**City Planning Commission
Meeting – May 26, 2015**

**CONSIDERATION – SUBDIVISION DOCKET – 049-15
Applicant: Greater New Home Baptist Church**

Prepared By: Brooke Perry
Date: May 14, 2015
Deadline: July 24, 2015

Proposal: Re-Subdivision of Lots 3 through 17, 20 and 21 into Lot 3A.

Figure 1: Proposed lot excludes several lots on the subject square. As a result, the proposed lot shape is highly irregular with two frontages on N. Roman Street.

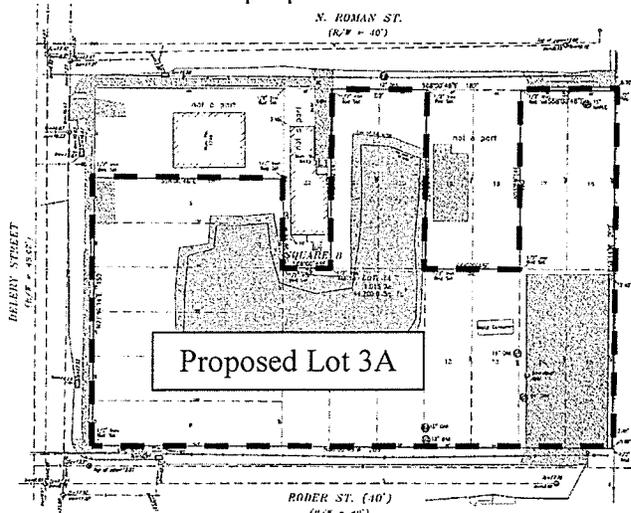
The proposed lot is located several blocks from the major street of Claiborne Avenue and is intended for institutional use, therefore the multiple frontage is not required to provide separation of residential development from major streets. The topography at the site is flat and surrounding land uses are residential, which is compatible with institutional development. The staff did not find any instances of similar lot development in the area. The site is currently undeveloped, thus the applicant has the ability to reconfigure the lots to provide ample fire access and off-street parking.

Subdivision Docket 049/15 is a request to re-subdivide Lots 3 through 17, 20 and 21 into Lot 3A. The existing lots are currently undeveloped and the applicant intends to construct a church on the proposed lot. The proposed re-subdivision would create a highly irregular lot with multiple frontages. The *Subdivision Regulations* specifically prohibit multiple frontage lots except in cases where it is absolutely necessary. The staff believes that the proposed subdivision does not meet the criteria for double frontage lots and that the site could be reconfigured to accommodate the proposed church and meet the 20,000 square foot requirement without creating an unusual lot shape. Therefore the staff believes that the request does not constitute an improvement over the existing condition and cannot be supported under Policy B.

The staff recommends **denial** of Subdivision Docket 049-15.

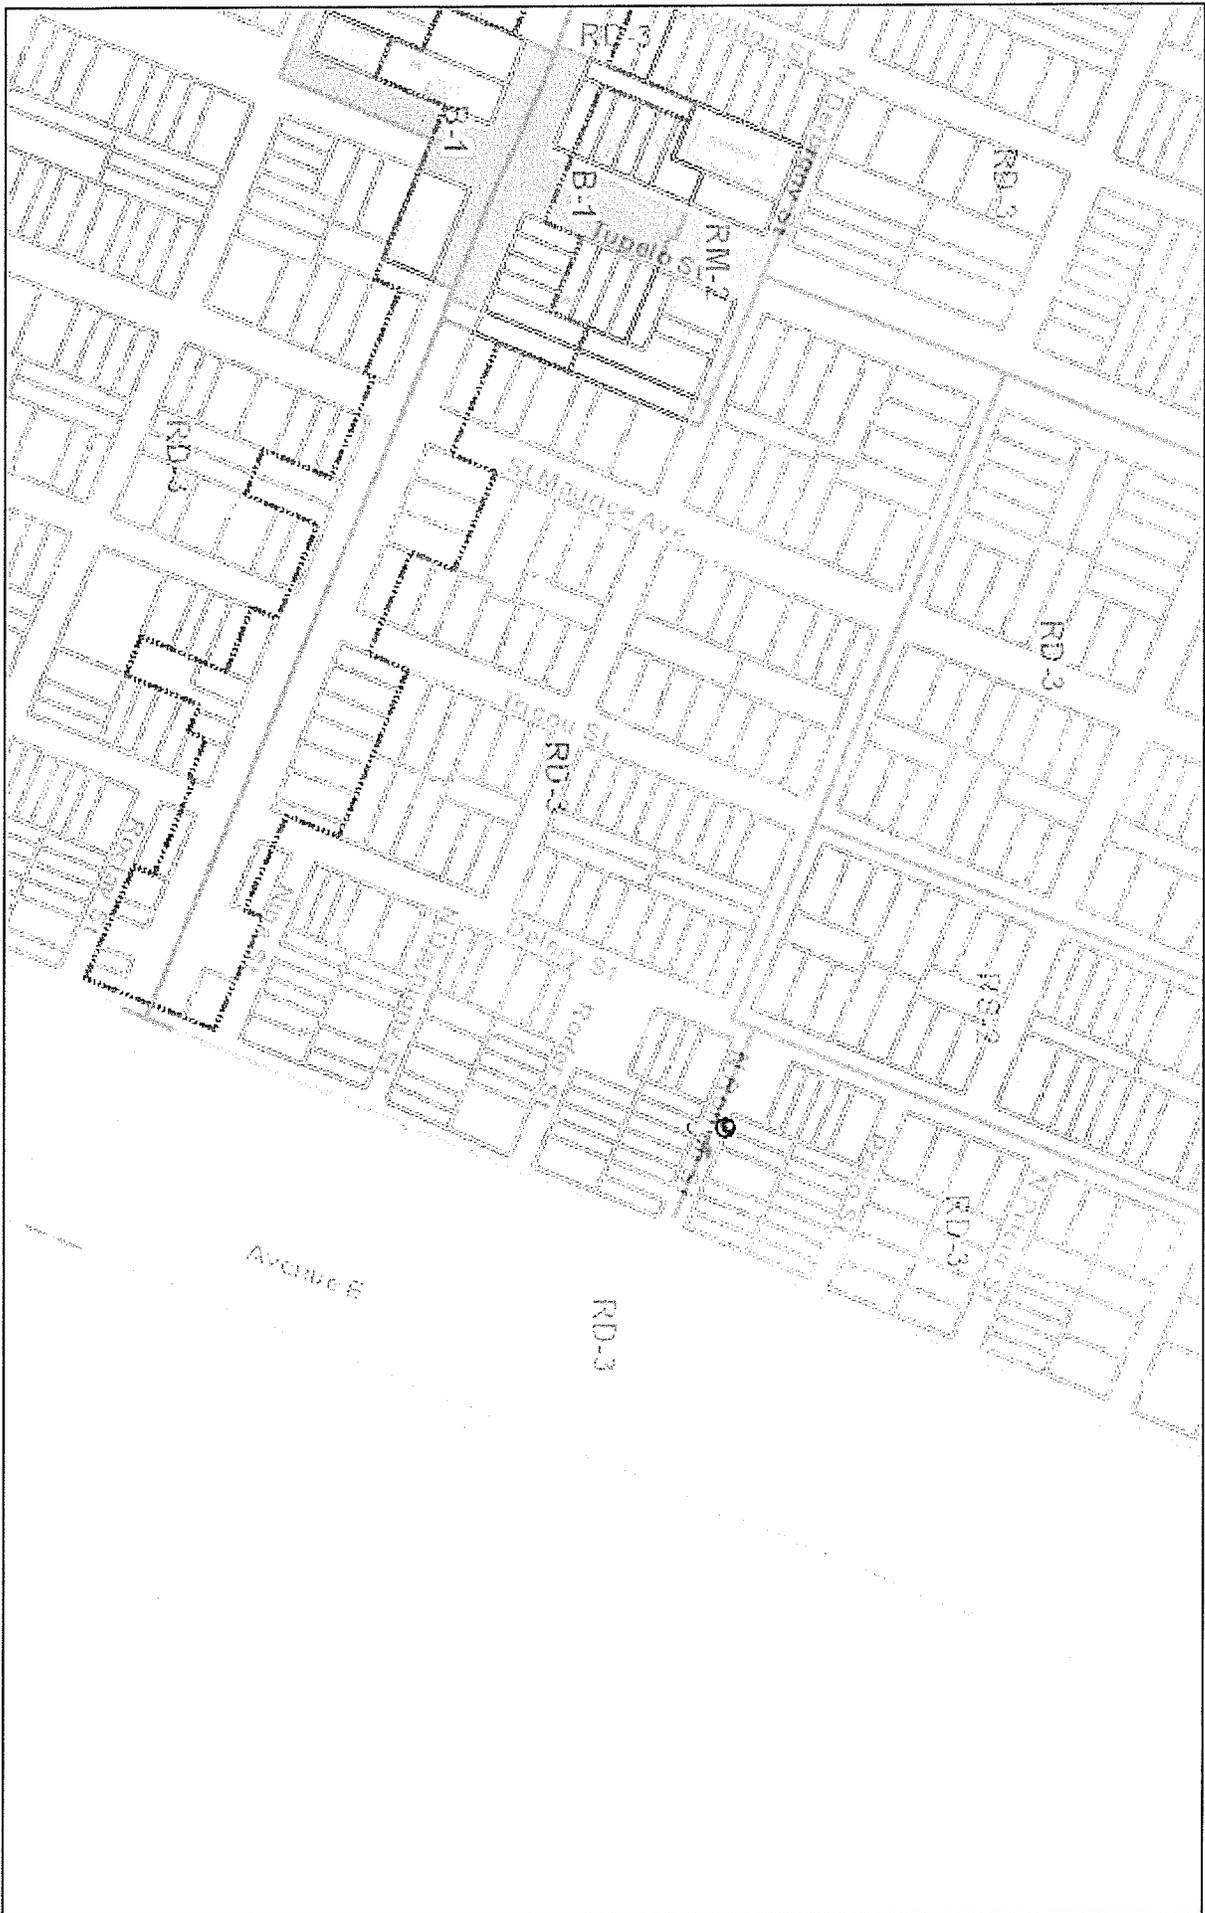
The Department of Property Management, Division of Real Estate and Records noted no objection to the survey, but noted the following objection to ownership:

Lot 6 is in the name of The Congregation of the New Home Baptist Church, Lots 11 & 20 are in the name of Greater New Home Missionary Baptist Church and lot 21 is in the name of Ninth Ward Greater New Home Missionary Baptist Church, Inc. The Subdivision letter of request should read Greater New Home

Baptist Church a.k.a. Ninth Ward Greater New Home Missionary Baptist Church, Inc., The Congregation of The New Home Baptist Church, & Greater New Home Missionary Baptist Church, Inc. The Subdivision letter of request mention lots 18 & 19 as one of the existing lots; the survey label lots 18 & 19 as not a part.

The representative of the Sewerage and Water Board stated that subsurface drainage was available, and noted that sewer and water facilities are available and that a note should be shown on the subdivision plans stating that sewer and water house connections are the responsibility of the property owner.
